UNITED STATES PATENT AND TRADEMARK OFFICE

APPLICATION NO.	FILING DATE	FIRST NAMED INVENTOR	ATTORNEY DOCKET NO.	CONFIRMATION NO.
10/708,928	04/01/2004	Kerry D. Hinson	60680-1780	2927
10291	7590	07/28/2005	EXAMINER	
RADER, FISHMAN & GRAUER PLLC 39533 WOODWARD AVENUE SUITE 140 BLOOMFIELD HILLS, MI 48304-0610			SHARP, JEFFREY ANDREW	
			ART UNIT	PAPER NUMBER
			3677

Office Action Summary

DETAILED ACTION

Baumann US-4,684,103

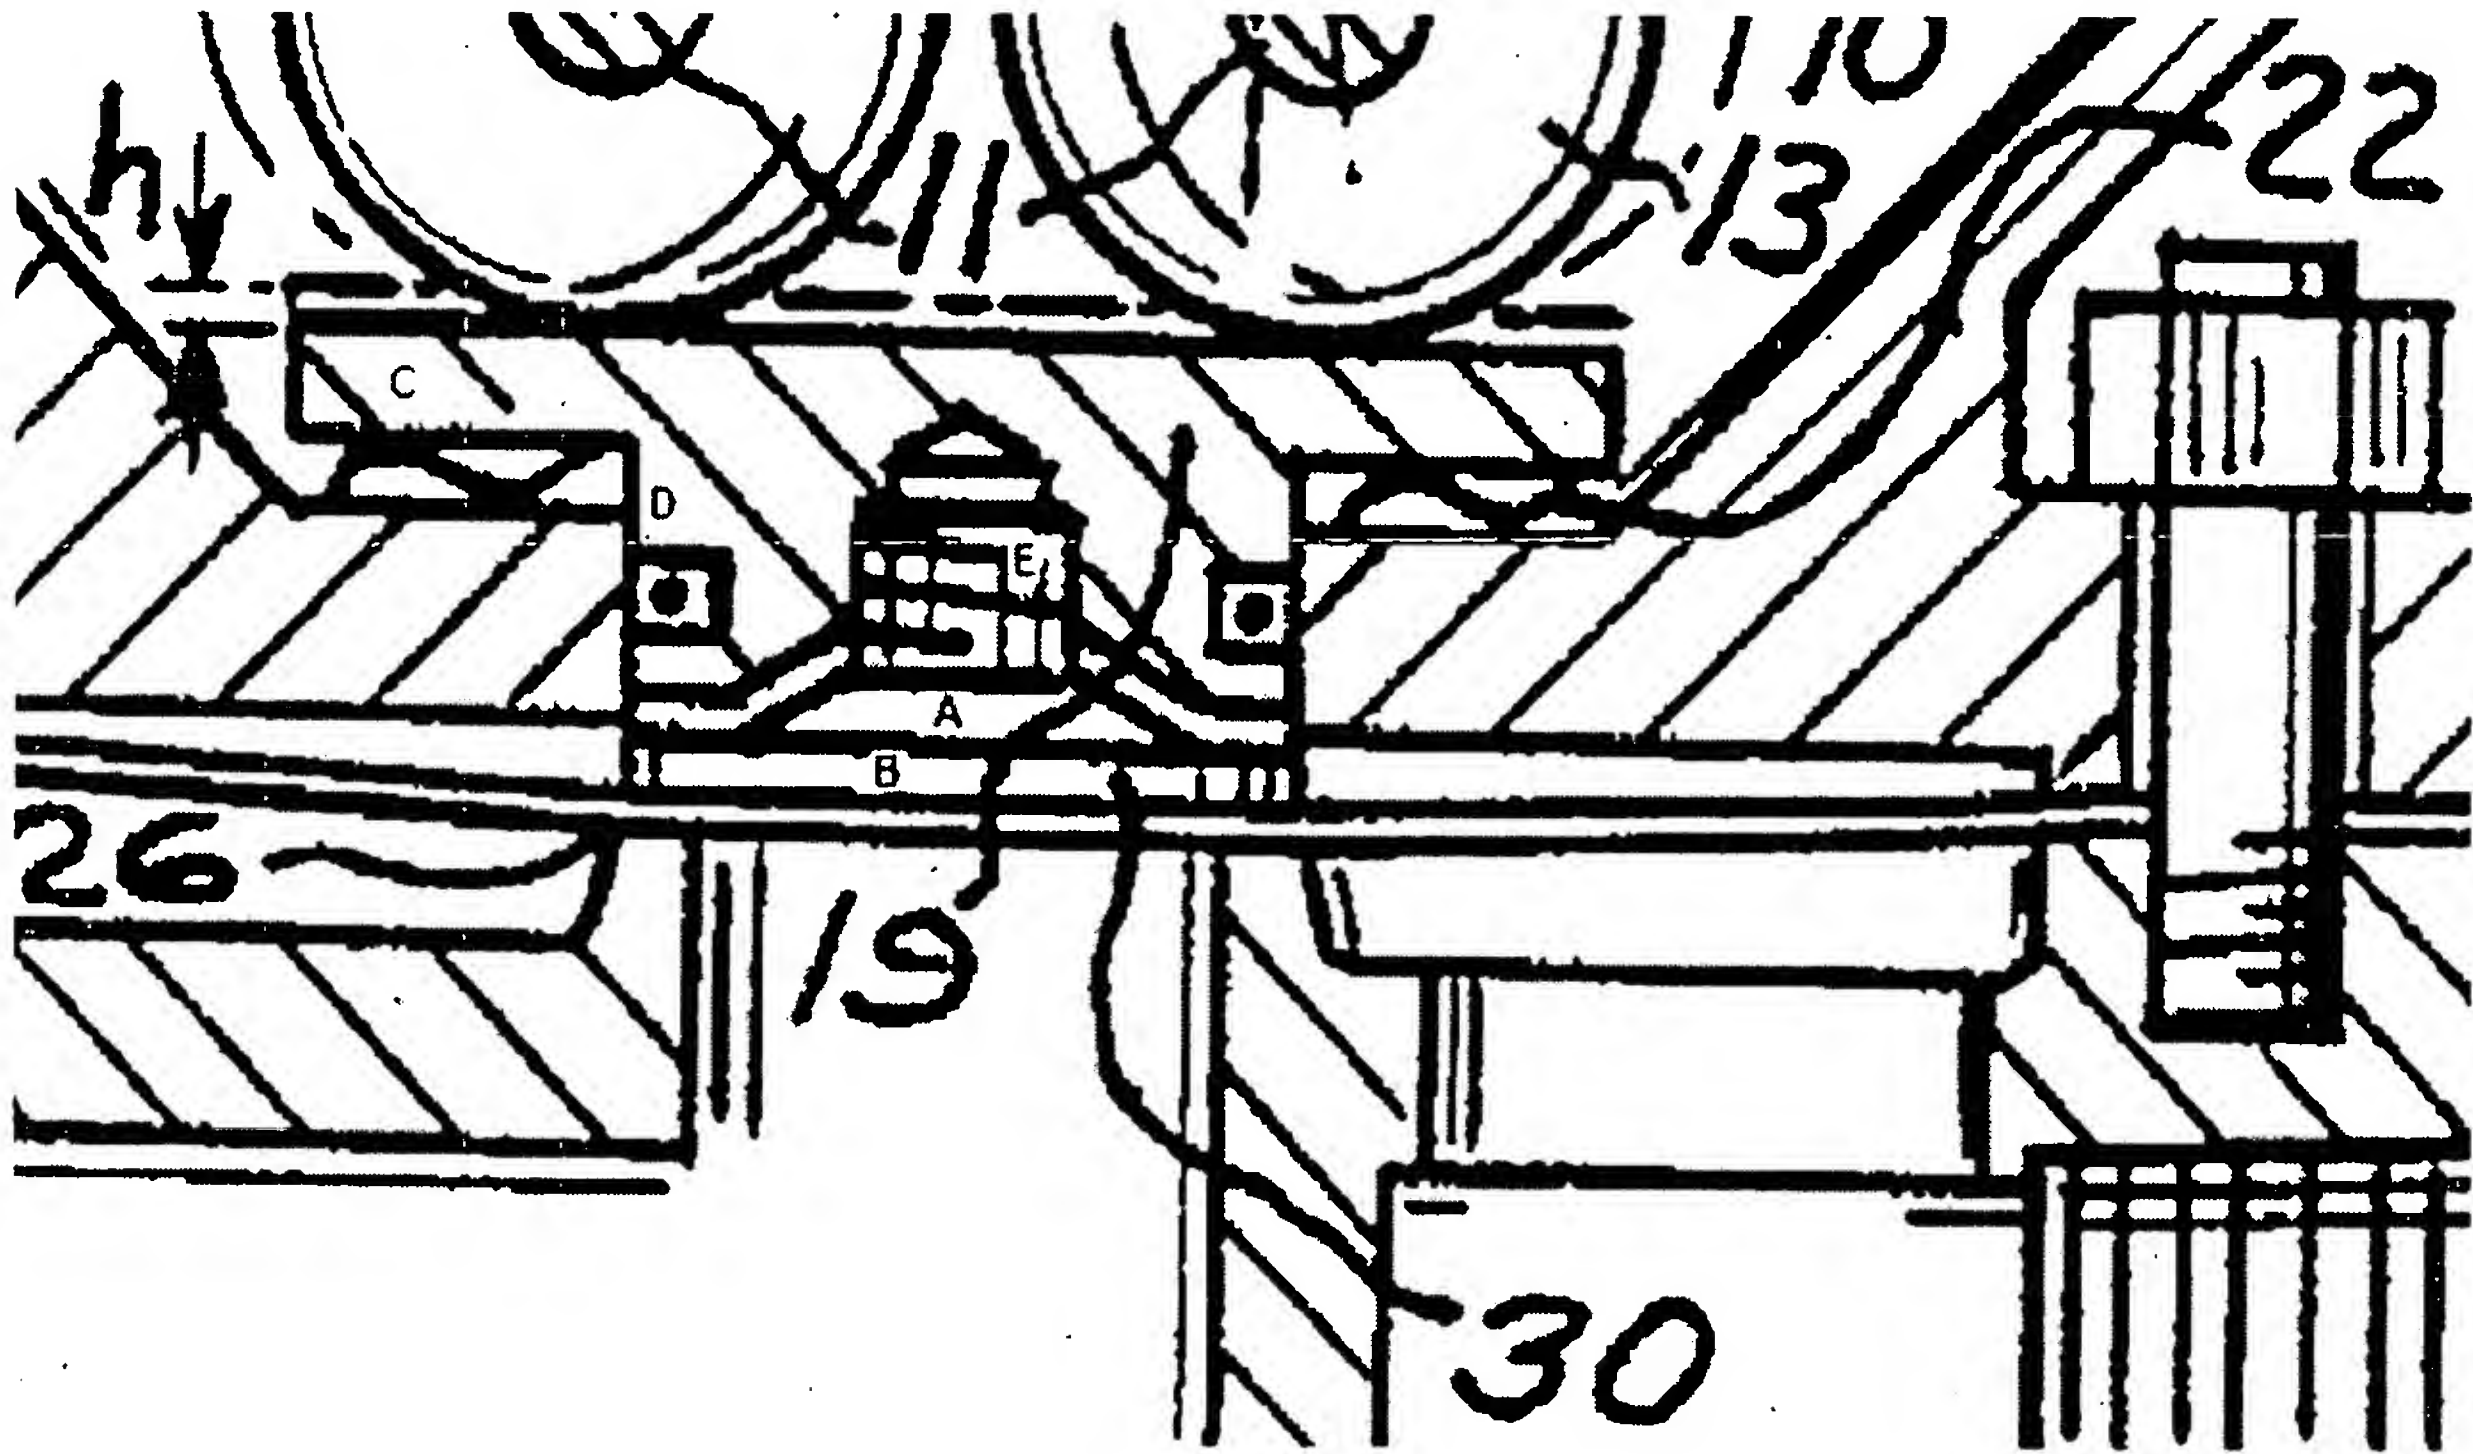
In short, Baumann teaches: a fastener assembly having a threaded fastener (30) having a head portion (A) and a shaft portion (E), a retention sleeve (19) disposed about the threaded fastener (30), and a wave spring (22) disposed about the retention sleeve (19), said wave spring

having an inner diameter slightly larger than an outer diameter of the retention sleeve (19). The fastener assembly acoustically decouples components (13) and (24).

Note that Baumann suggests a radially projecting collar (B) on the head portion (A) of the threaded fastener (3), pertinent to claim 3.

Note that Baumann suggests a radially outwardly projecting head flange (C) on the retention sleeve (19), pertinent to claim 4.

As for claim 5, the examiner takes the position that it would be obvious to one of ordinary skill in the art to make all components of a metal, as a preferred material, because it has been held to be within the general skill of a worker in the art to select a known material on the basis of its suitability for the intended use as a matter of obvious design choice. *In re Leshin*, 125 USPQ 416. It is also common knowledge to choose a material that has sufficient strength, durability, flexibility, hardness, etc. for the application and intended use of that material.

As for claim 6, the wave spring (22) abuts the retention sleeve (19), such that it never fully compresses (only deflects a distance h in a compressed state).

Note that the retention sleeve (19) has a downwardly extending "necking portion" (D), that extends downward from the flange section (C).

Hu et al. US-6,745,995

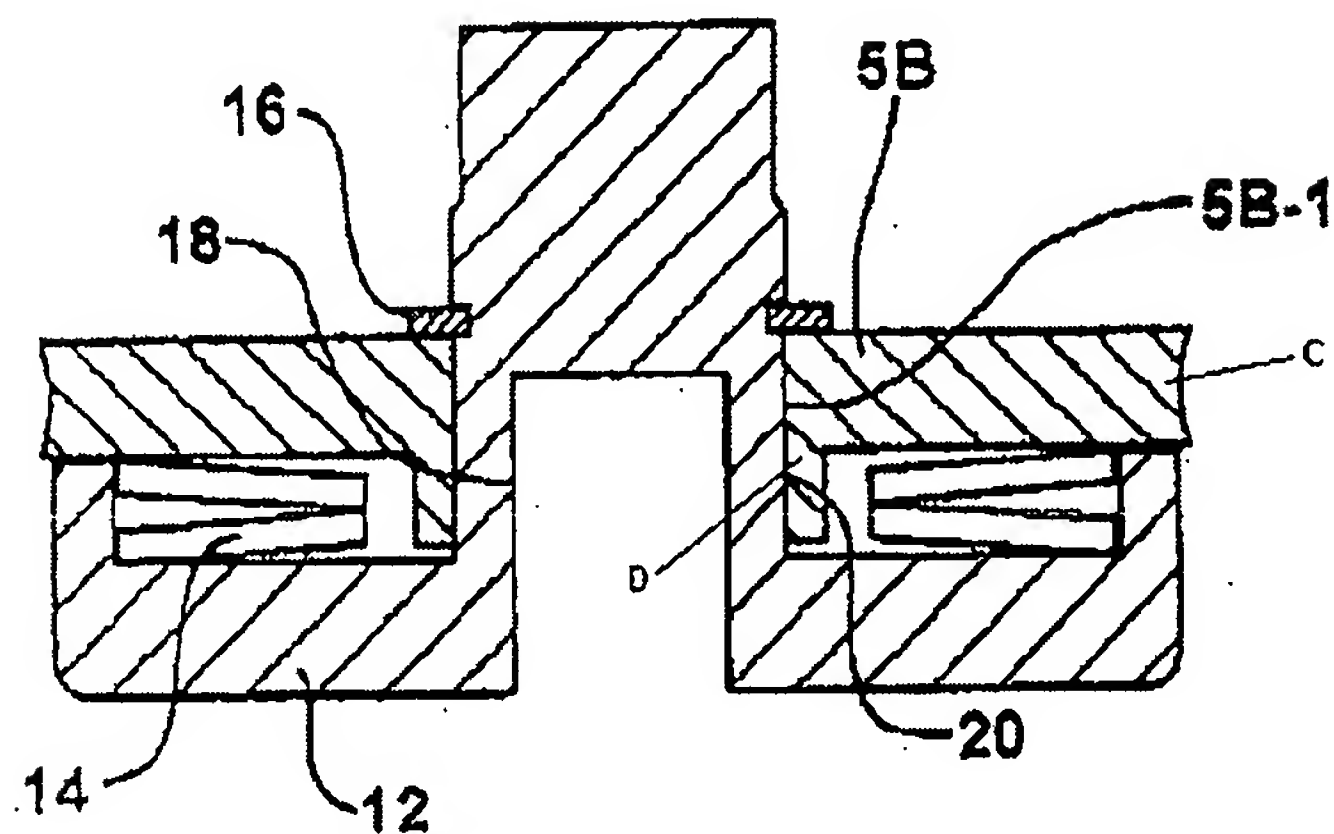
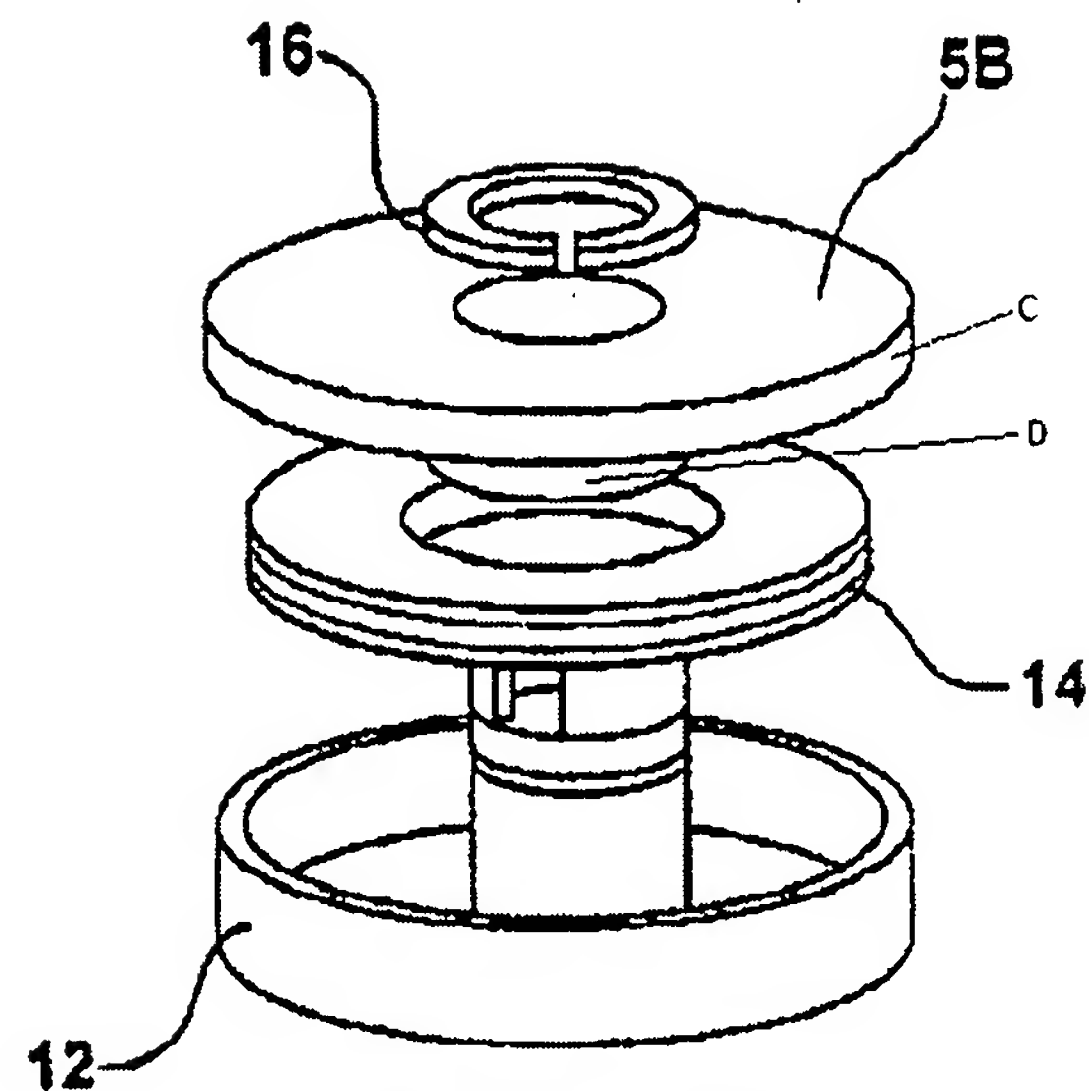
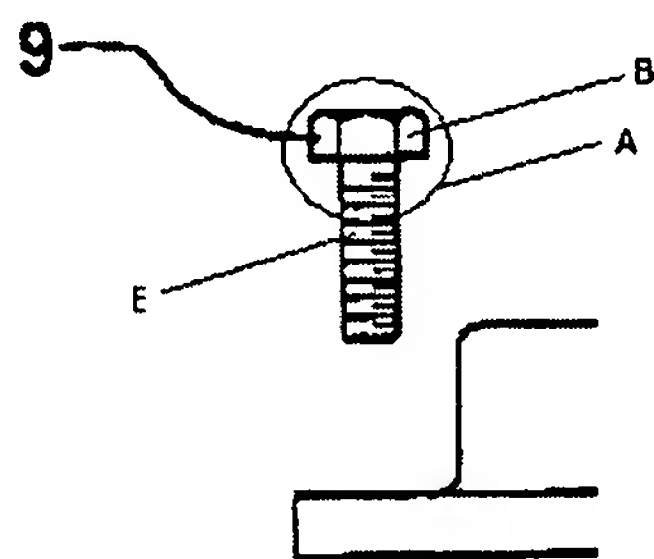
In short, Hu et al. teach: a fastener assembly having a threaded fastener (9) having a head portion (A) and a shaft portion (E), a retention sleeve (5b) disposed "about" the threaded fastener (9), and a wave spring (14, col. 5 lines 48-50 & 56-57) disposed about the retention sleeve (5b), said wave spring having an inner diameter slightly larger than an outer diameter of the retention sleeve (5b). The fastener assembly acoustically decouples components (16) and (12).

Note that Hu et al. suggest a radially projecting collar (B) on the head portion (A) of the threaded fastener (9), pertinent to claim 3.

Note that Baumann suggests a radially outwardly projecting head flange (C) on the retention sleeve (5b), pertinent to claim 4.

As for claim 6, the wave spring (14) abuts the retention sleeve (5b), such that it never fully compresses.

Note that the retention sleeve (5b) has a downwardly extending "necking portion" (D), that extends downward from the flange section (C).
